# City of Hutto

### Zoning Board of Adjustments

**Tuesday, January 23, 2024 at 7:00 PM**

**To:** Zoning Board of Adjustment  
**Subject:** Consideration of a public hearing and possible action regarding a variance request for the property located at 2725 Limmer Loop from the requirements as outlined in Chapter 10, Section 10.307.6.3 of the Unified Development Code (UDC), to allow a car wash closer than the minimum 50-foot distance from a residential zoning district boundary.  
**Meeting:** Tuesday, January 23, 2024  
**Department:** Development Services  
**Staff Contact:** John Byrum

# Car Wash: Scenario A

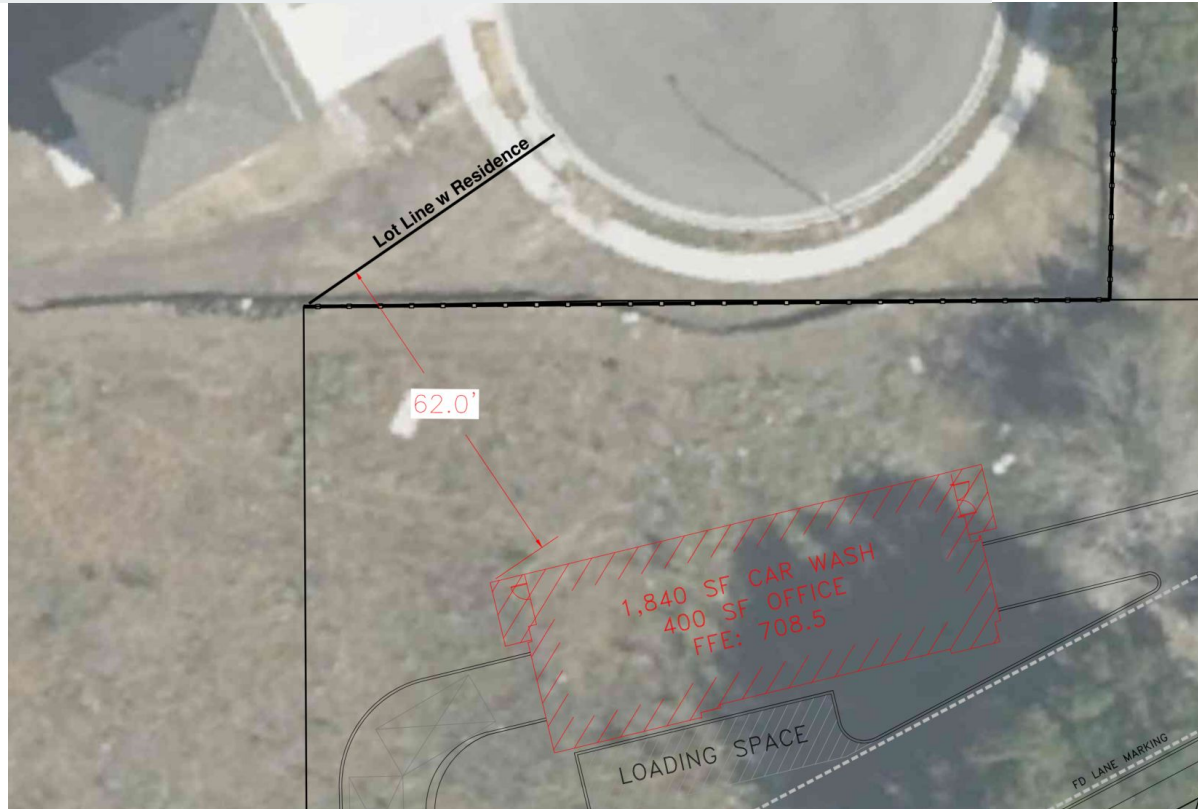
| UDC Criteria for Variance Approval                                                                                                                                                                     | Sandlin Services Response                                                                                                                                                                                                                                                                                                                                                                                                                                                                                                                                                                                                |
|--------------------------------------------------------------------------------------------------------------------------------------------------------------------------------------------------------|--------------------------------------------------------------------------------------------------------------------------------------------------------------------------------------------------------------------------------------------------------------------------------------------------------------------------------------------------------------------------------------------------------------------------------------------------------------------------------------------------------------------------------------------------------------------------------------------------------------------------|
| There are unique conditions peculiar to the parcel, such as an unusual shape, that do not exist on adjacent parcels.                                                                                   | The commercial lot is inhibited by a diagonal, large gas line easement that runs northwest to southeast that creates a peculiar usable building area. This disallows the car wash to be pushed any further south to meet the strict interpretation of the setback requirement from the open space lots. The open space lots are uninhabitable but zoned as Single Family. If the car wash were placed on the adjacent commercial lot to the north (See Exhibit A), it would meet the 50' setback requirement, and ironically place the car wash 20% closer to an inhabited single-family lot than the proposed location. |
| Strict application of this code deprives the applicant of rights commonly enjoyed by other land in the area or land with a similar zoning designation.                                                 | Strict application of this code, currently being employed, considers the undevelopable, open space lots as an inhabitable space instead of an additional buffer zone. In reality, the open space lots and cul-de-sac provide an additional buffer and total separation distance of 62' from the first inhabited single-family lot line, <b>exceeding code requirements by 24%.</b>                                                                                                                                                                                                                                       |

- 50' Setback is 20% closer to SF Home than Scenario B

- 24% (12') further from a Single Family Lot with residence than compliant, Scenario A

- There are unique conditions peculiar to the parcel, such as an unusual shape, that does not exist on adjacent parcels.
  - False. While there is an Atmos Energy 100' wide pipeline easement that affects the western side of the property, the easement does not render the site unbuildable or provide less buildable area than the code maximum of 5,000 square feet. The site is still buildable and the applicant can provided an alternative location showing the car wash location in compliance with the Unified Development Code.

- Conditions resulting in the request are not self-created by disregard or ignorance of this code.
  - False. The applicant submitted a site plan that does not meet the minimum adopted development codes and has also proposed an alternative location for the car wash that meets the minimum code standards. As shown in Scenario A, the car wash could be parallel to the western property line, meet the setback requirement, and allow the entry/ exit of the car wash to be perpendicular to the residential area, providing more noise attenuation. In addition, if the entrance is at the south as shown on the exhibit, the automobile lights would be less likely to point directly towards the adjacent homes, as the driver would be required to take a right out of the car wash, in the opposite direction of the common property line. Scenario A is only one option for the car wash location. As proposed in Scenario A, the drainage pond shown on the schematic would have to be relocated. In summary, there is sufficient space on the property to satisfy the minimum code requirements in a number of ways.

- The variance is the minimum necessary to grant relief.
  - False. The applicant has shown another location of the car wash that would meet the UDC standards as adopted.
